**REQUEST FOR PROPOSAL – ONE STEP PROCESS
CONSTRUCTION MANAGER AT RISK
RELOCATION OF FIRE STATION #1
QUESTIONS AND ANSWERS**

RFP No. S16-029

Q&A No. 1

Date: August 1, 2016

A1.1
FLOOR PLAN & WALL TYPES

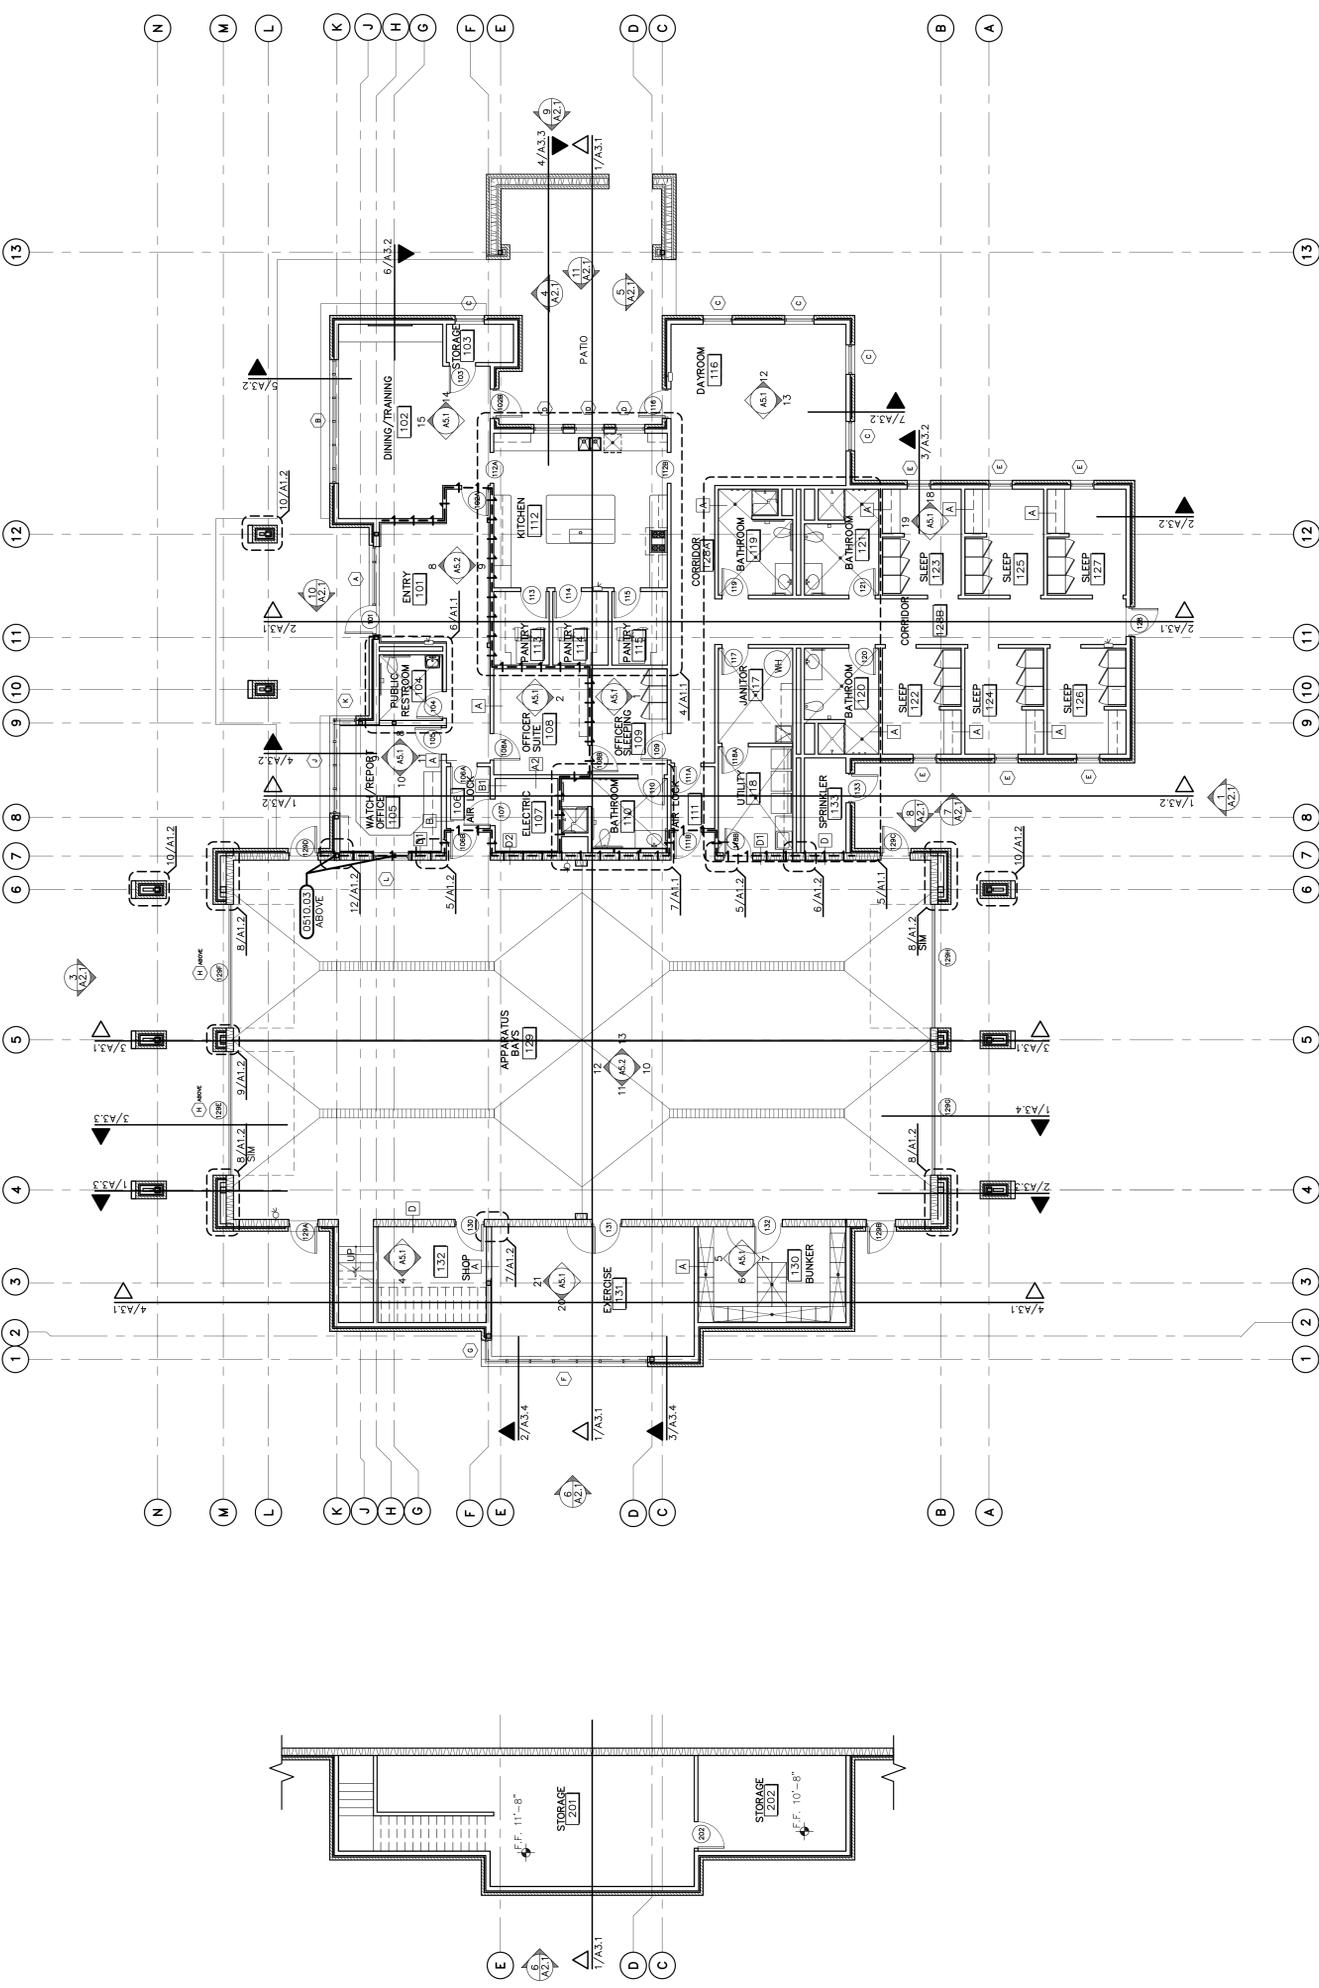
- 3. Q: Are the plans for Fire Station #4 available?**
A: A schematic is attached herein.
- 4. Q: Where will Fire Station #1 be relocated to?**
A: To a location on San Gabriel Parkway. The address has not yet been assigned.
